Revised Bioremediation Implementation Process Figure (Figure 5-1) from June 2008  
Groundwater Decommissioning Plan for Cimarron Site, Crescent, OK

**Bioremediation Implementation Process**

Cimarron Corporation  
Crescent, Oklahoma

**5-1**

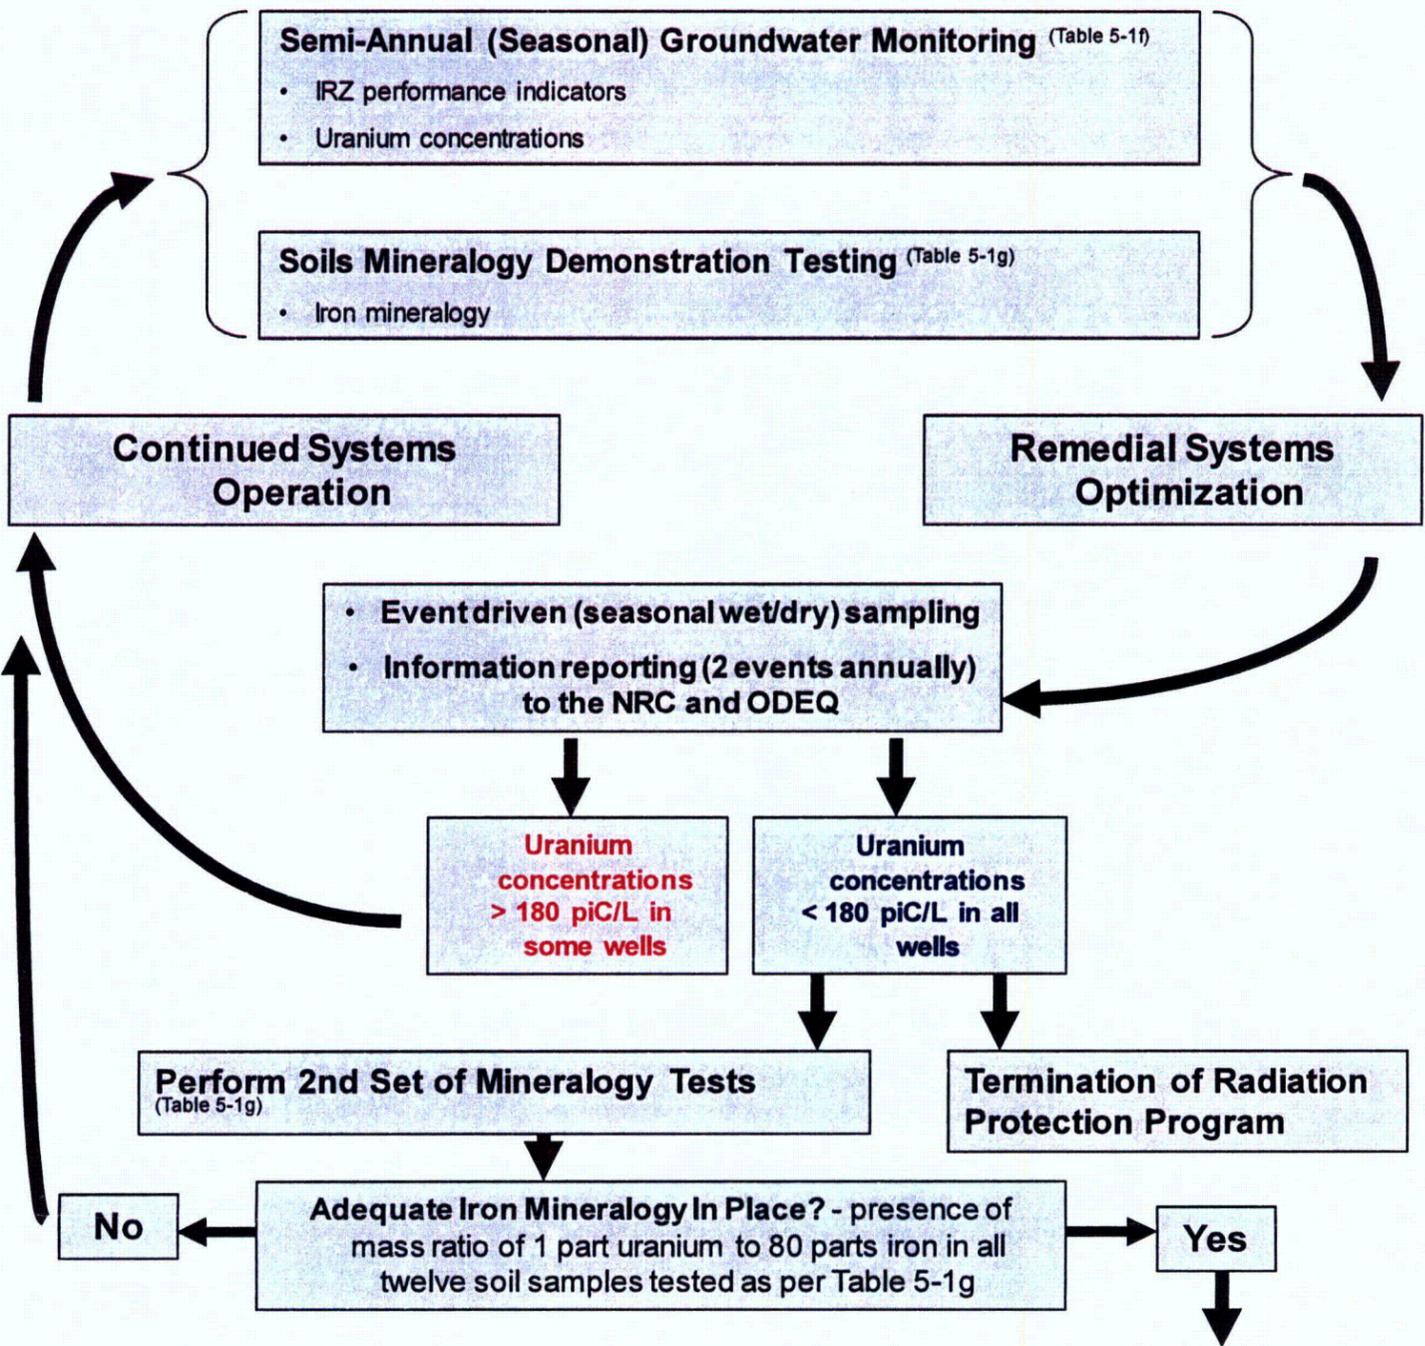
On behalf of Cimarron, ARCADIS is providing the attached revised Figure 5-1 depicting the Bioremediation Implementation Process proposed for the Cimarron site. As requested by the NRC during our October 22, 2008 conference call to discuss the Addendum, we have revised the Bioremediation Implementation Process figure (Figure 5-1 in the June 2008 GDP) to reflect the currently proposed bioremediation process for the Cimarron site, including achievement of the four success criteria prior to proceeding from initial treatment testing to full-scale remediation, and the completion of the laboratory column testing earlier in the overall treatment process. In addition, we have tied the proposed monitoring included in Table 5-1 more closely with each of the steps in the flow chart for clarity.
